AMENDMENTS TO THE DRAWINGS

2624
09/ 470,234

FIG. 1

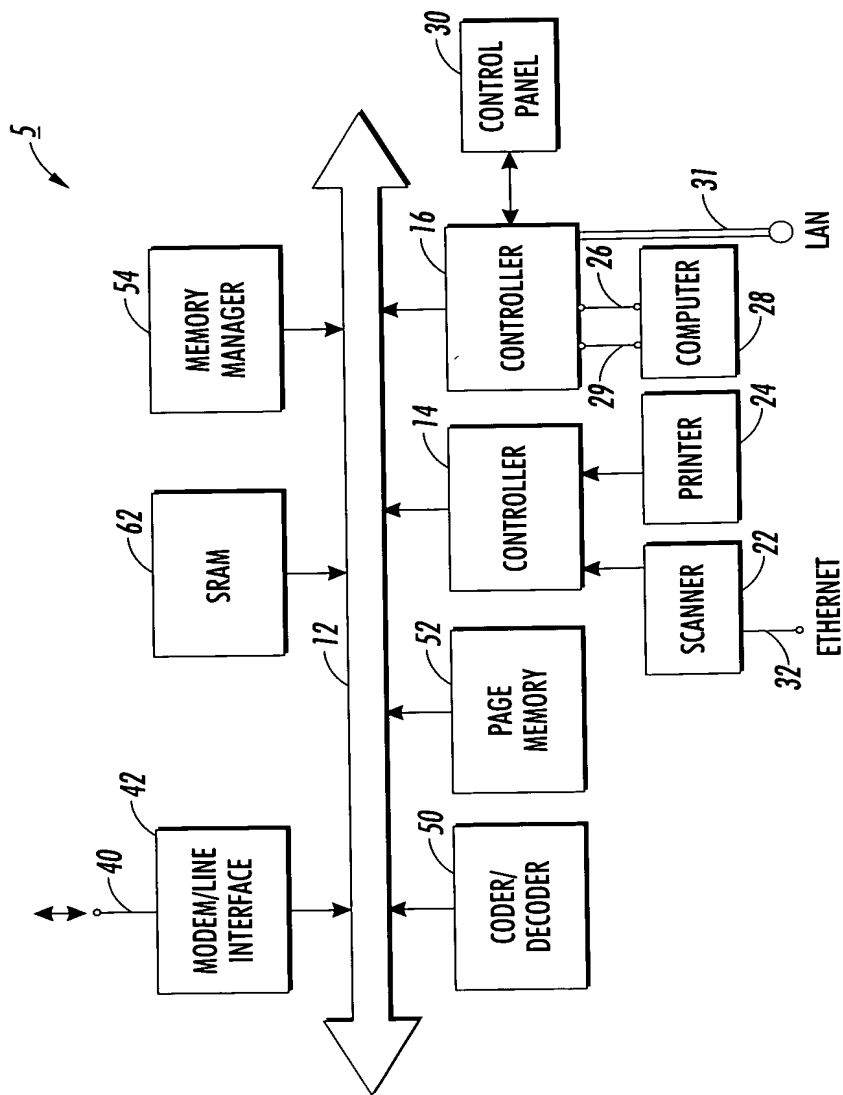
The drawings were objected to as failing to comply with 37 C.F.R. 1.84(p)(4) because reference character, for example, "24" of Figure 1 and Figure 6 has been used to designate both motor and printer. In response, the motor in Figure 6 has been renumbered 18.

The drawings were objected to as failing to comply with 37 C.F.R. 1.84(p)(5) because they do not include the following reference sign(s) mentioned in the description: for example, roller 18, substrate 14 of page 5, transfer assist apparatus 50 of page 6, specification, is not shown in Figure 6. In response, roller 18 has been renumbered 20 with appropriate changes in the specification, and substrate 14 has been labeled in Figure 6. The text on page 6 now makes clear that a transfer assist apparatus is not shown in Figure 6.
